LISS FOREST NURSERY, GREATHAM, LISS, HAMPSHIRE
FILE NOTE DEALING WITH LLFA COMMENTS DATED 19 OCTOBER 2021

Drawing ref: ENC-240918-USA9	Date: Oct 2018
------------------------------	----------------

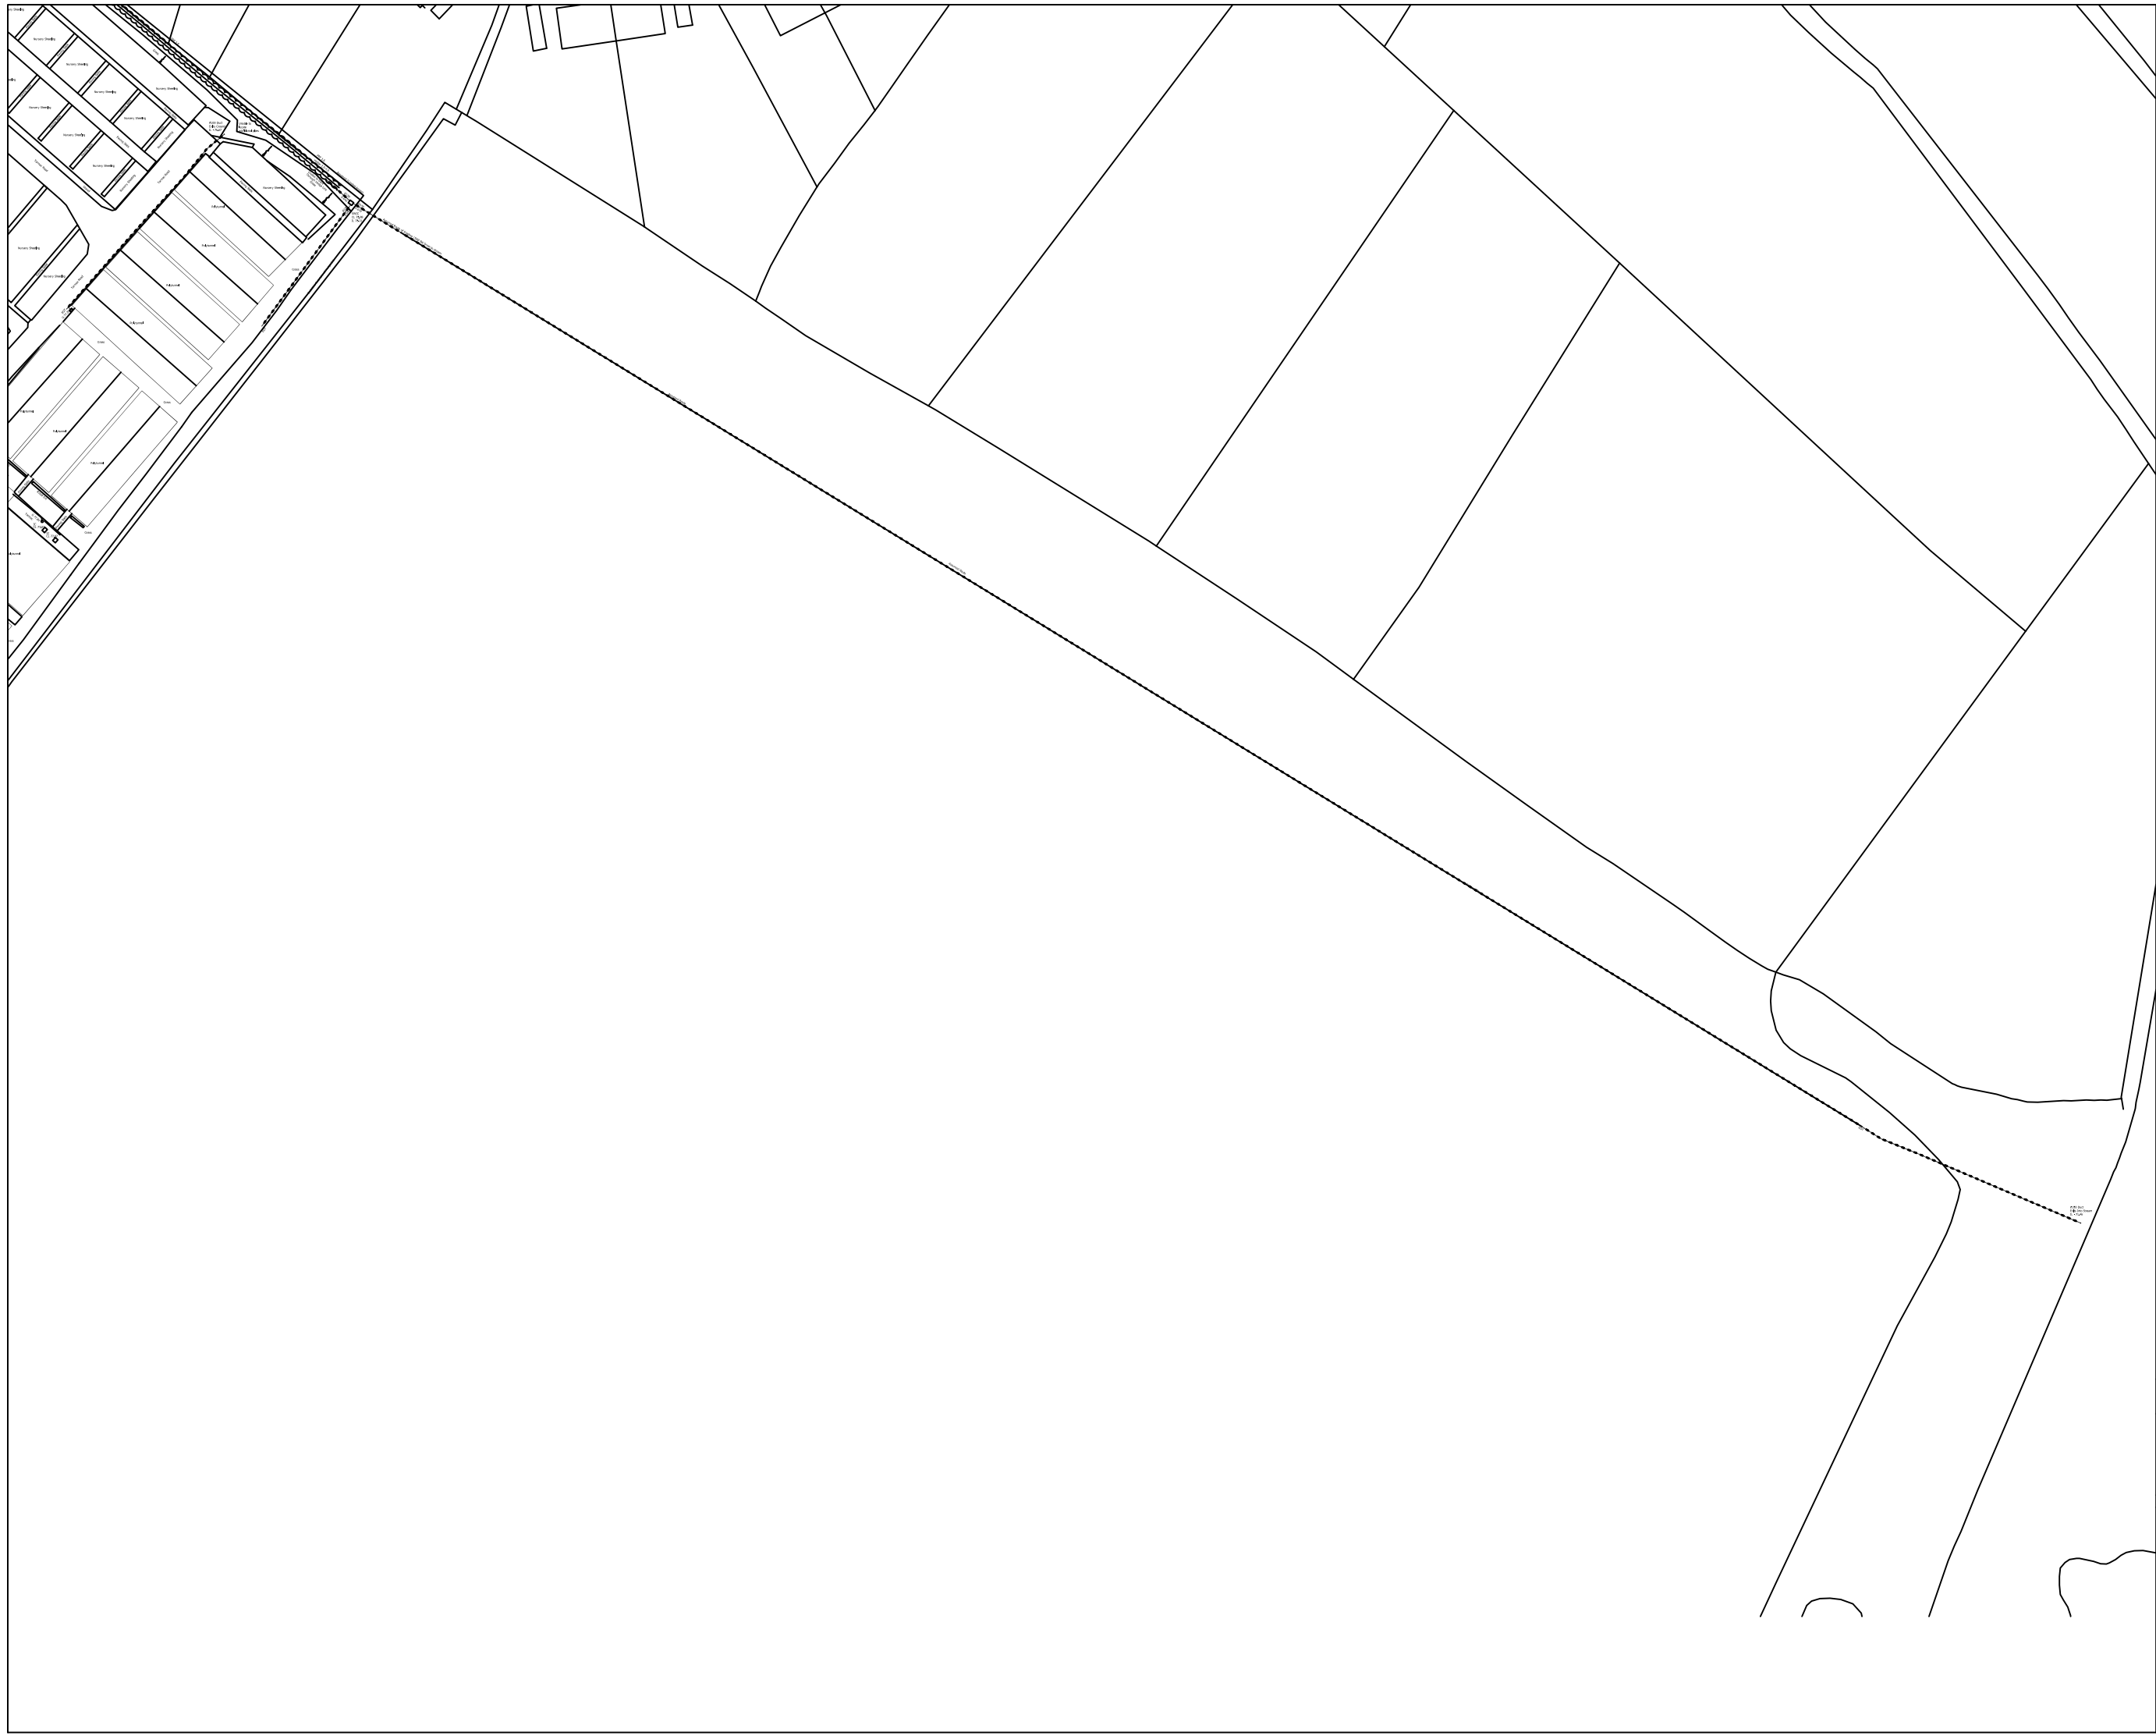
1. The topographical survey included in Appendix 3 in the FRA shows a number of drainage features, but does not provide full details for the drainage systems serving the existing development on the site. A site investigation by PFA consulting on 30 July 2018 showed that the existing drainage systems on the site connect to the head of an outfall pipe at the north-east corner of the site, within the site boundary; the outfall to the Ordinary Watercourse at the downstream end of the outfall pipe was also identified.

The upstream and downstream ends of the outfall pipe were subsequently surveyed by Encompass Surveys in October 2018; a copy of the Encompass survey drawing reference ENC-240918-U5A9 is reproduced in **Appendix 1**. Based on the surveyed levels at the upstream and downstream ends of the outfall pipe, the average gradient would be 1 in 76; the corresponding pipe-full chart capacity would be 20.6 l/s. The peak discharge rate from the proposed development would be limited to a maximum of the greenfield runoff rate QBAR, equivalent to 11.4/s. The existing outfall pipe would therefore have sufficient capacity to convey the peak discharge rate from the proposed development however the proposed sewer design is lower than the upstream end of the existing outfall pipe so a proportion of the existing pipe will need to be relayed at a gradient of 1 in 150, giving a capacity of 14.5l/s, connecting into the existing pipe with an inspection chamber where the inverts of the proposed and existing pipes coincide.

Notwithstanding the above, the Developer has secured a legal easement that establishes rights in perpetuity to utilise, survey and repair/ replace the outfall pipe. A condition survey and any necessary remedial works could therefore be covered by a suitably worded planning condition.
